TO: Chairman Oz Nesbitt, Rockdale County
ATTN TO: Kalanos Johnson, Director Planning and Development, Rockdale County
RE: Development of Regional Impact (DRI) Review
FROM: Mike Alexander, Director, ARC Center for Livable Communities

Name of Proposal: Preserve at Honey Creek DRI 3450

PRELIMINARY COMMENTS:

PRESERVE AT HONEY CREEK DRI
Rockdale County
Natural Resources Group Comments
December 16, 2021

CONCEPT PLAN

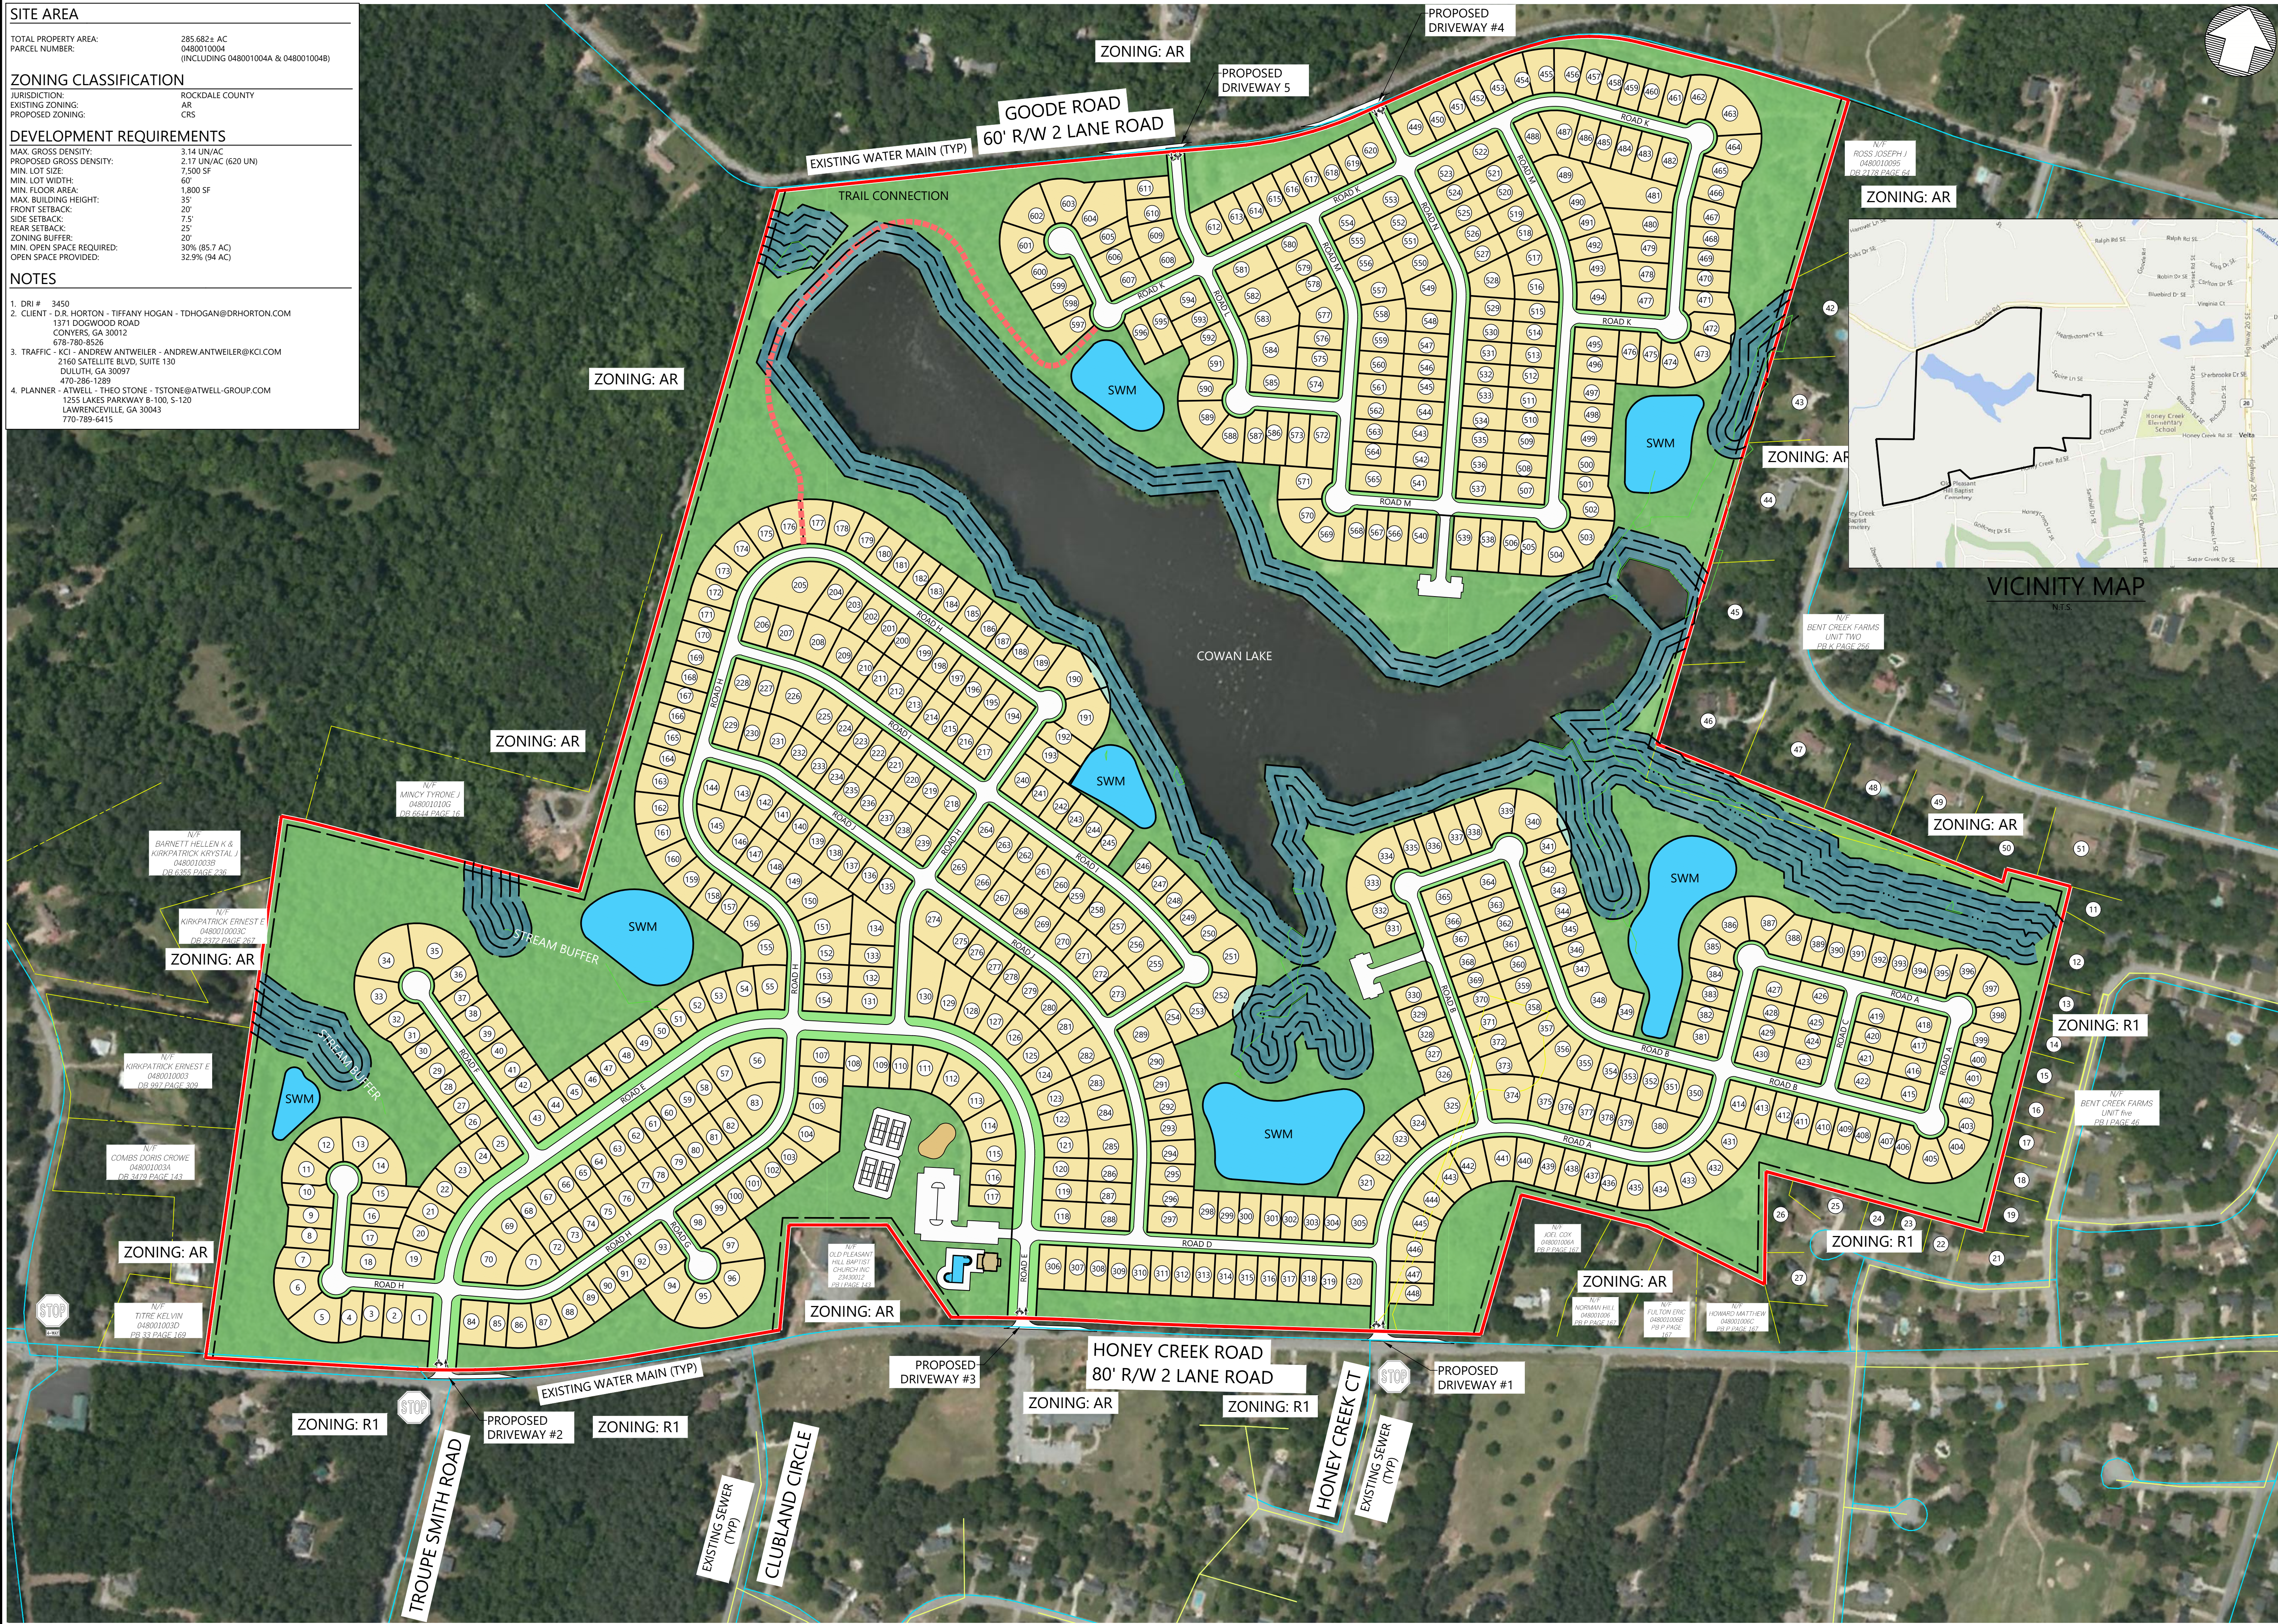
It is not clear from the site plan if the project will include an internal sidewalk system. A basic sidewalk system, ideally connecting to sidewalks along Honey Creek Road leading to the Honey Creek Elementary School just a few blocks from the site, would be supportive of regional multi-modal transportation policies.

It is not clear from the site plan if the project will include an internal sidewalk system. A basic sidewalk system, ideally connecting to sidewalks along Honey Creek Road leading to the Honey Creek Elementary School just a few blocks from the site, is considered a fundamental transportation and mobility requirement for all new developments in the region. The proposed walking trail connecting the north and south sections of the project is supportive of regional transportation policies; the provision of additional trails would be even more so.

The USGS coverage for the project area shows streams at either end of Cowan Lake as well as an intermittent stream flowing into an unnamed tributary of Honey Creek. The submitted site plan shows these streams on the property as well as four other stream segments shown on the property. Although not identified, with no legend on the plans, buffers that appear to be the County 50-foot undisturbed buffer and 75-foot impervious setback, as well as the State 25-foot Erosion and Sediment Control buffer are shown on all streams as well as Cowan Lake. The only intrusion shown on the plans is a trail crossing one end of Cowan Lake. The trail is subject to the requirements of the County and State buffers and may require a variance. Any unmapped streams on the property may be subject to the Rockdale Buffer ordinance. Any

Additional retention of the substantial existing wooded areas on the site would be desirable and in keeping with regional goals regarding carbon sequestration and climate change/heat island effect mitigation.
